**DOE/LX/07-0343&D2
Primary Document**

**Explanation of Significant Differences
to the Record of Decision for the Interim Remedial Action
of the Northwest Plume at the
Paducah Gaseous Diffusion Plant
Paducah, Kentucky**

Date Issued—December 2010

Figure 5. Locations of New and Preexisting Extraction Wells Associated with the Northwest Plume IRA at PGDP

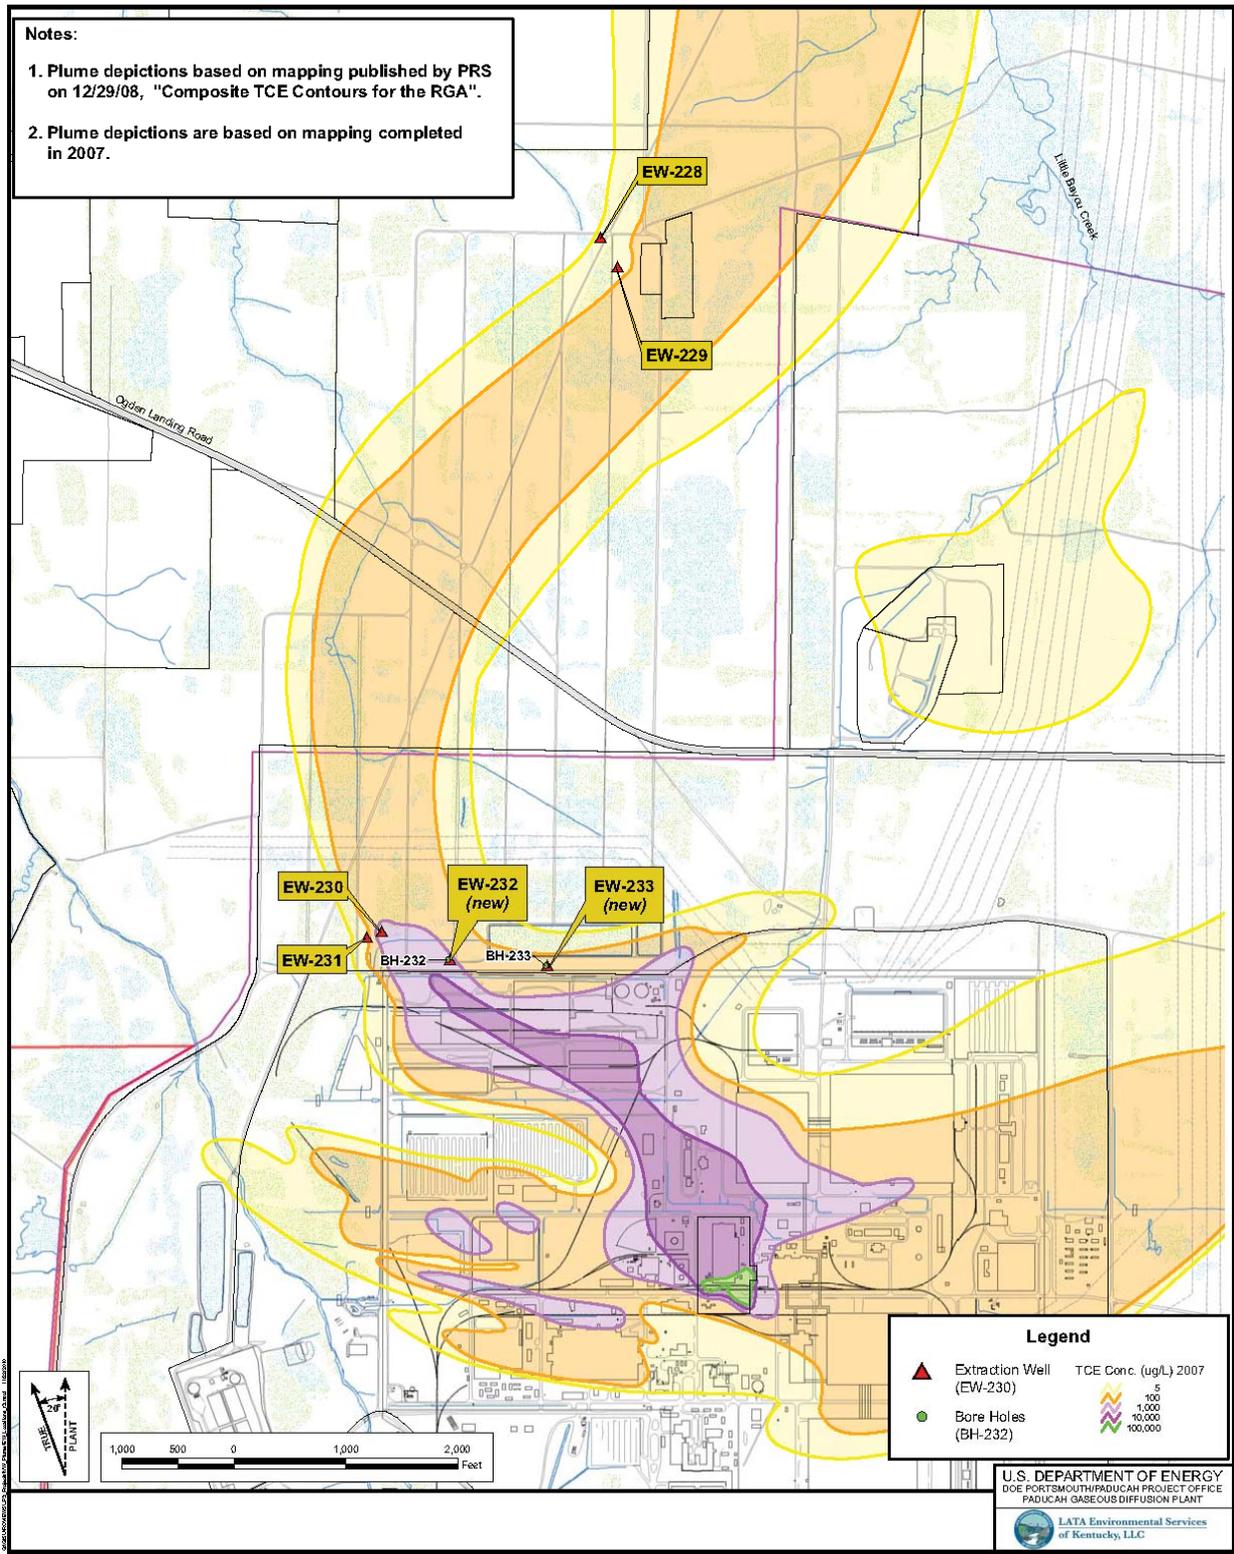
- The existing south EWs, EW230 and EW231, are out of service, but will remain in standby mode, to be made operational with minimal effort, and will be replaced by two new EWs located east of the EW230 location.

- The design and placement of the two new EWs (EW232, EW233) were based on modeling results and on geotechnical data (grain size analyses and lithologic logs) gathered from boreholes installed in close proximity to the proposed well locations.

Well field optimization modeling indicates that a two-well configuration is optimal. The two new wells, EW232 and EW233, are located north of the fence line at the northwest corner of PGDP. Refer to Figure 5 for well locations. The EWs have a design capacity 220 gpm each, as allowable by the formation. Boreholes were installed approximately 10 to 12 ft from the proposed locations for the two new EWs. Detailed lithologic logs and grain size analysis was used in well screen and filter pack design.
